### HISTORIC DISTRICT COMMISSION

Regular meeting

6:30 p.m. September 3, 2025

- A. Certificate of Appropriateness Application: **311 W. Orange St.** - New construction house (PIN 9864883297)

Sheet Title:  
Exterior  
Elevations

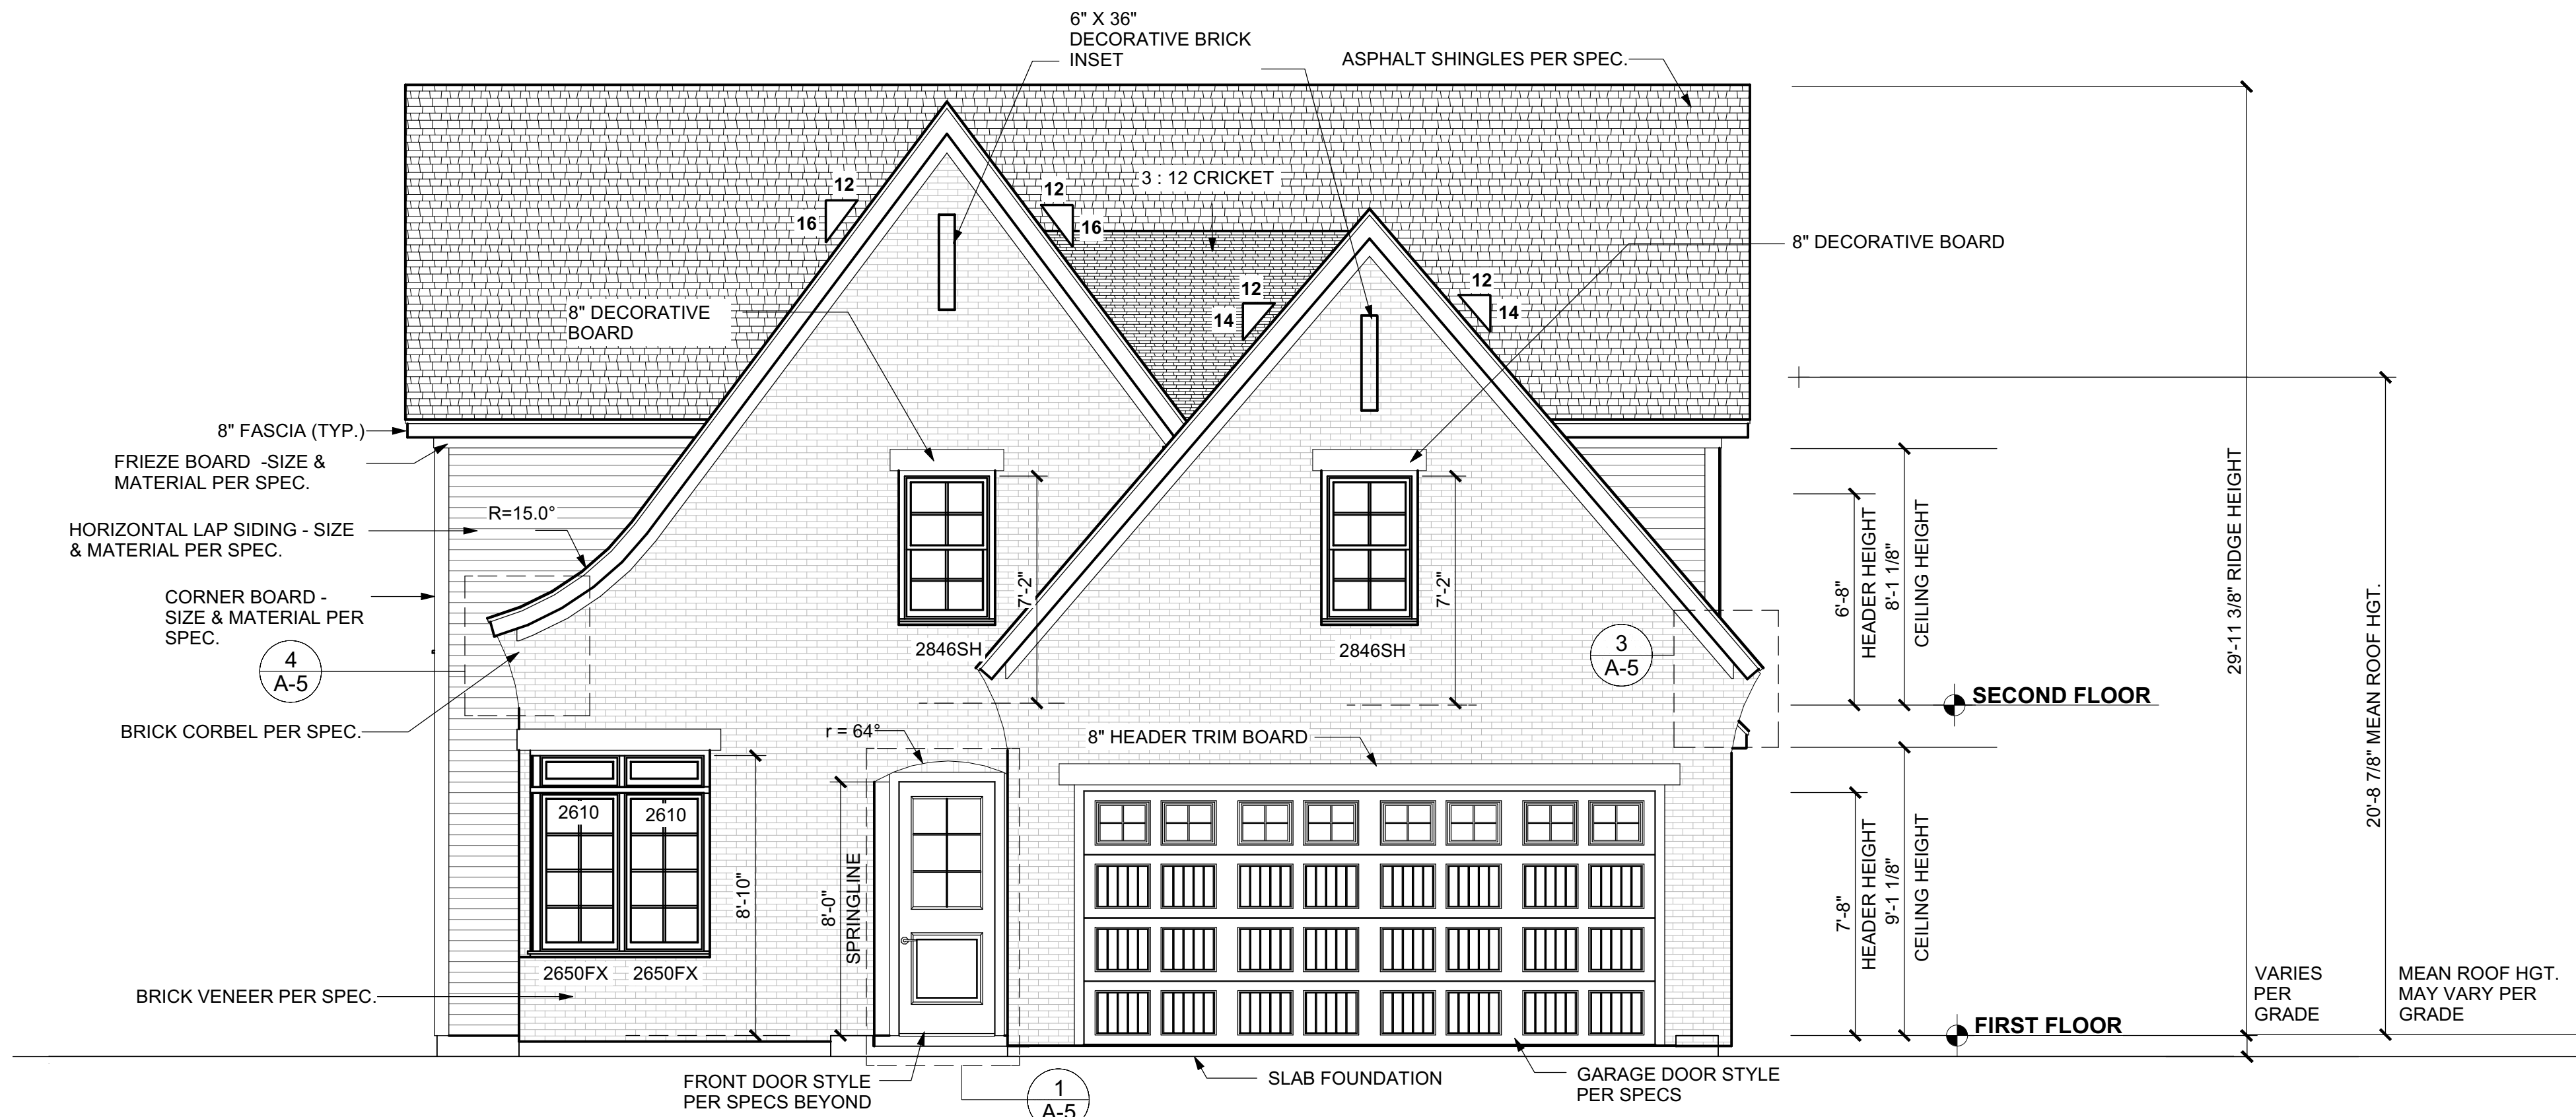
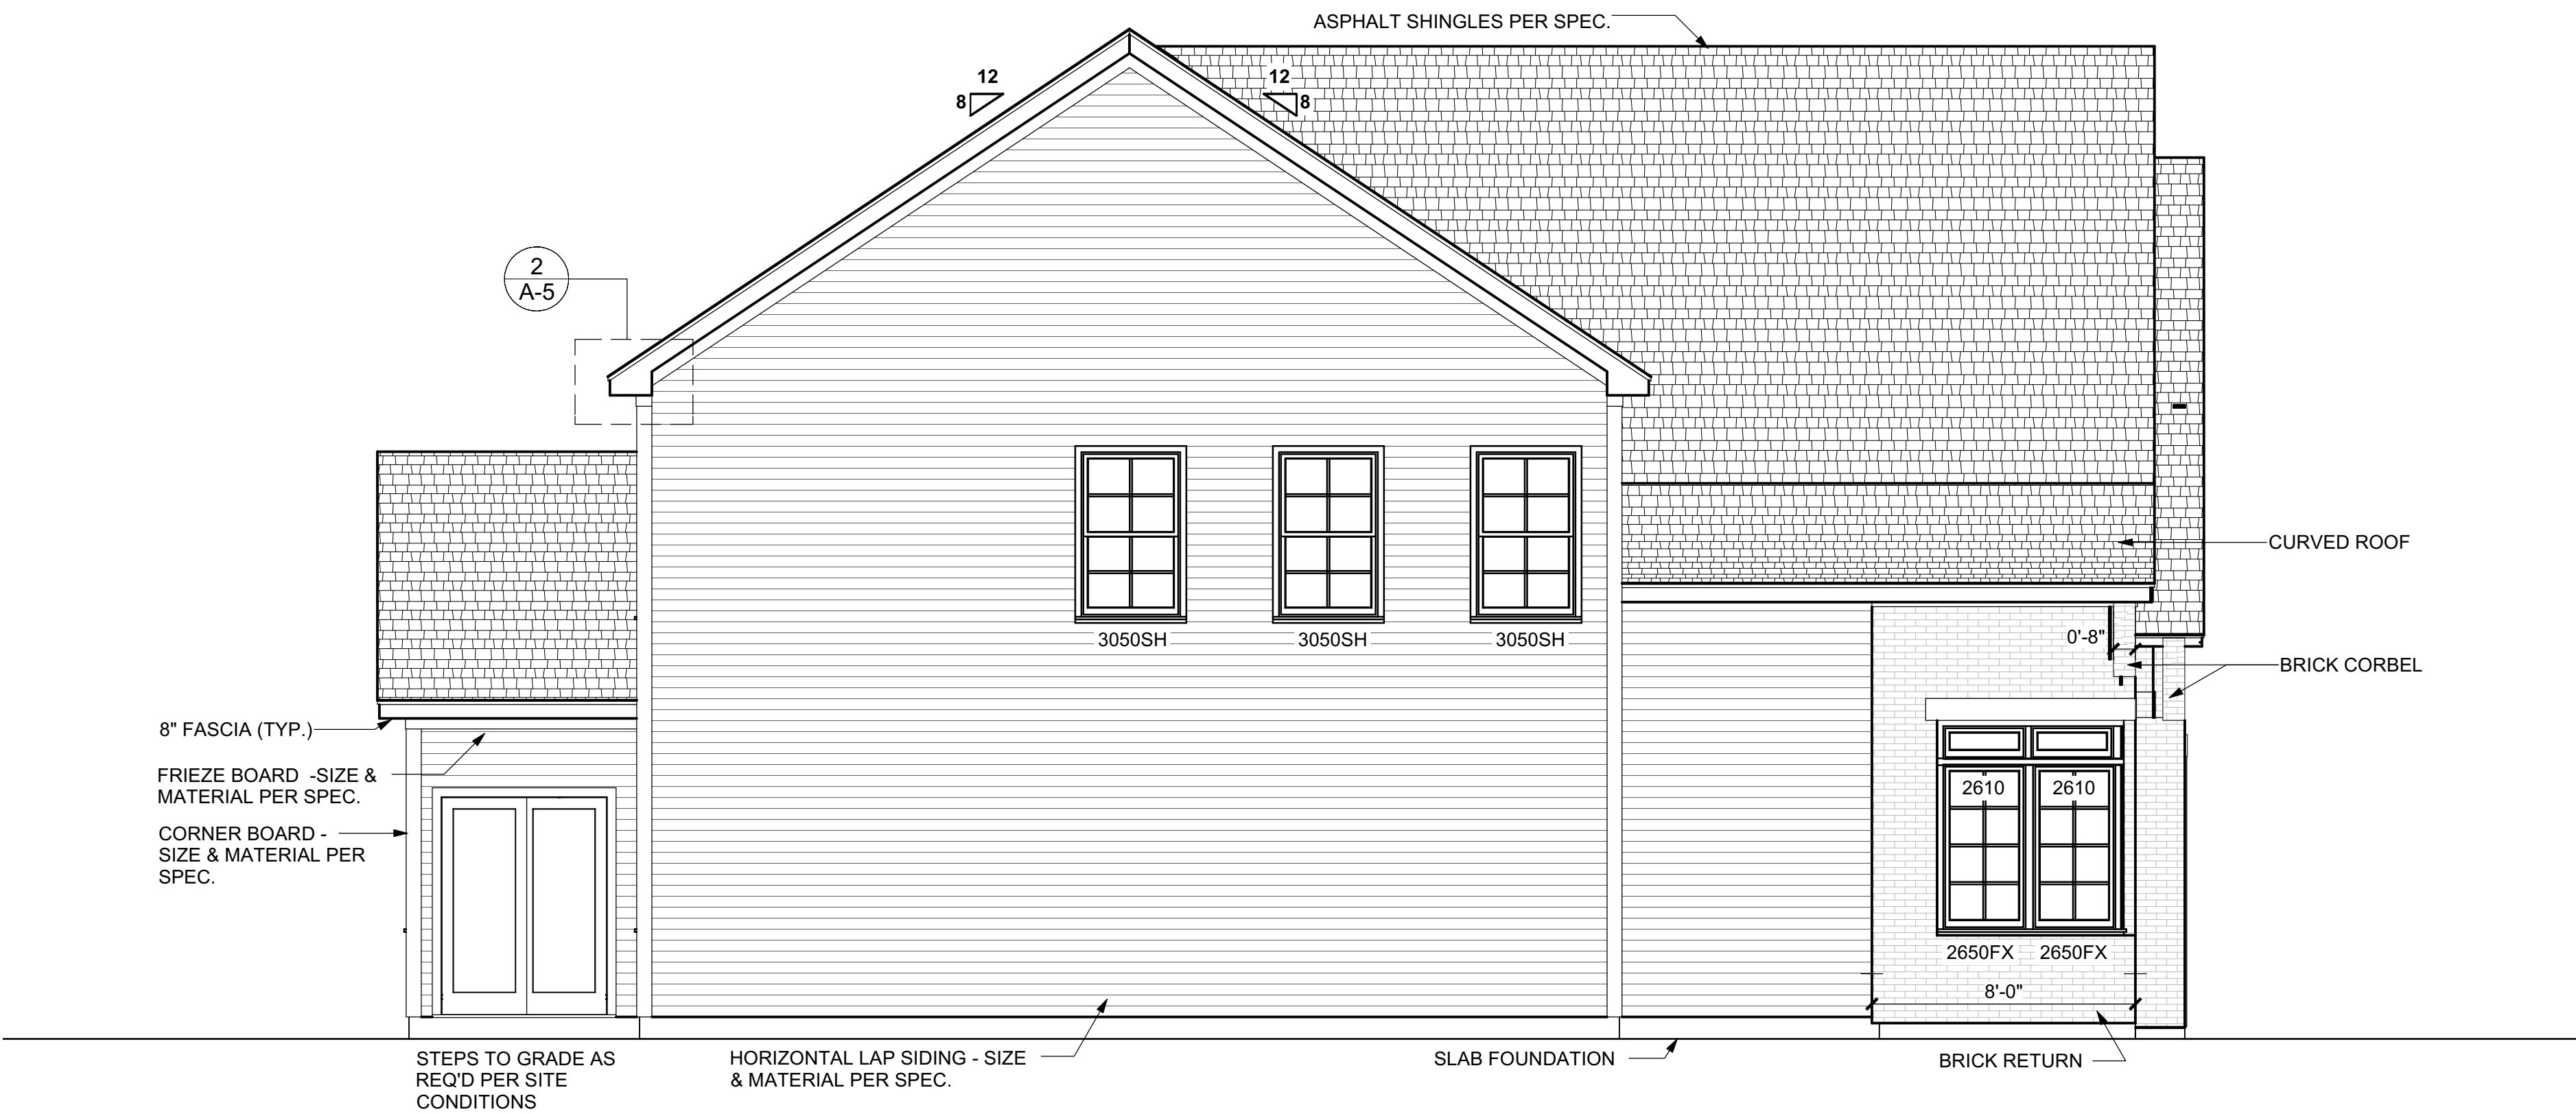
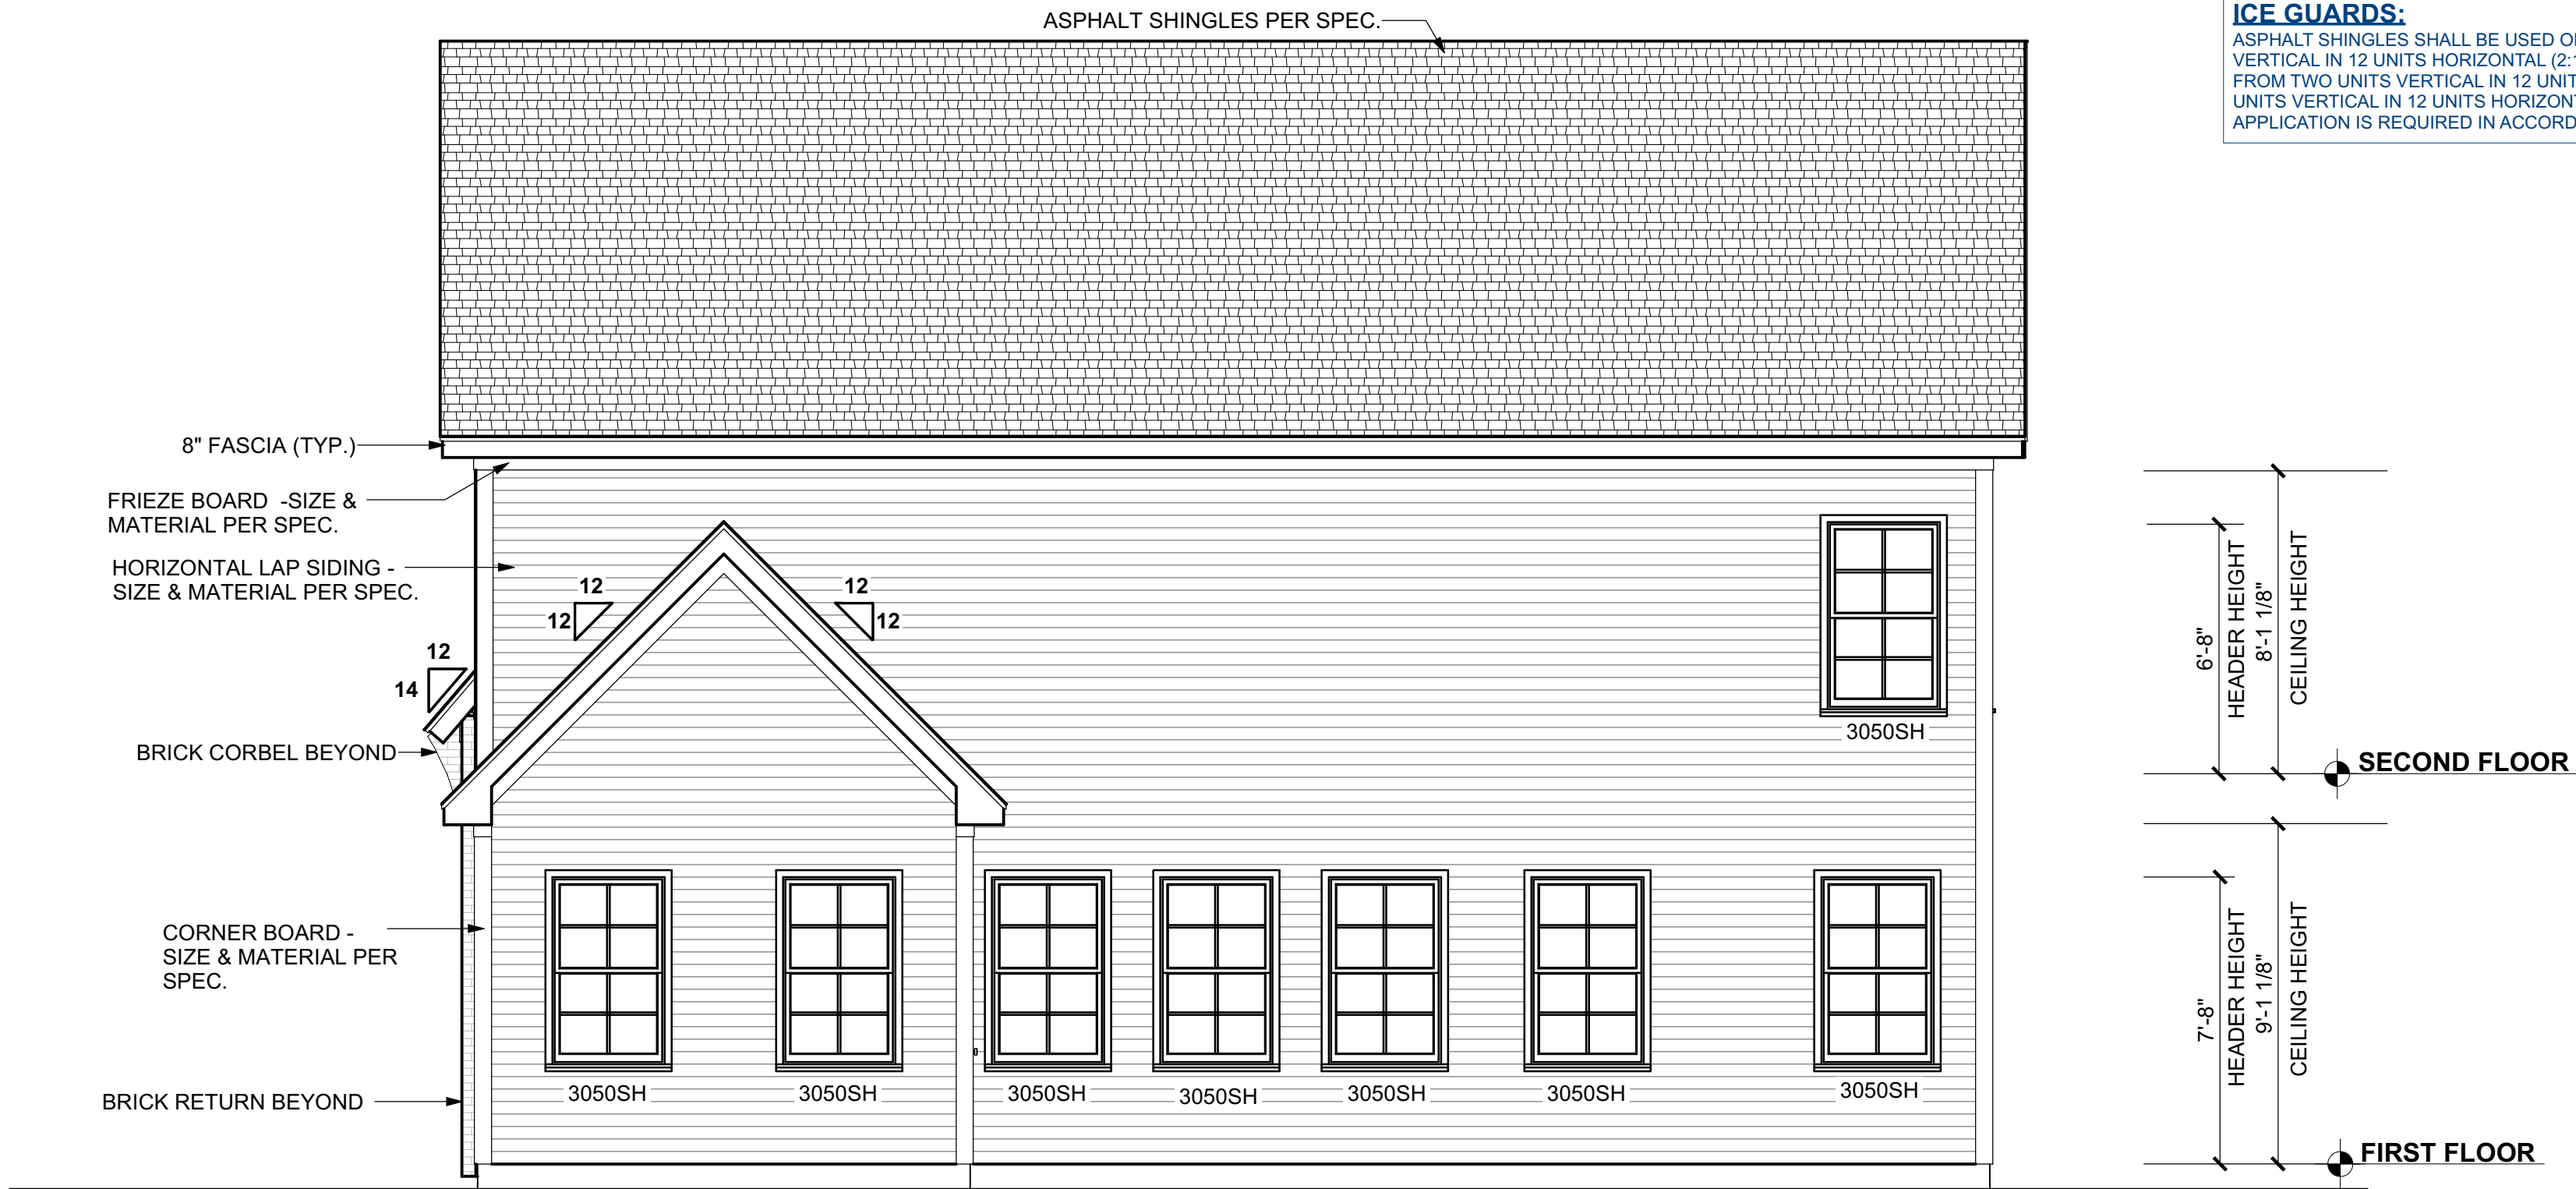
It was observed that the plans are missing a materials listing for the garage door. There were questions about the intent of the screened porch being marked as "optional."

The commissioners said they would like to see as much supporting evidence as possible to show that this architectural style and design is congruent with the district. They also said that they would like to see how these plans are congruent without trying to imitate a home of an earlier era. The commissioners had concerns about the curve and pitch of the roof. They said they would like to see clear thought and strategy for how the house and driveway could be sited to minimize disruption to the site in terms of trees and grading.
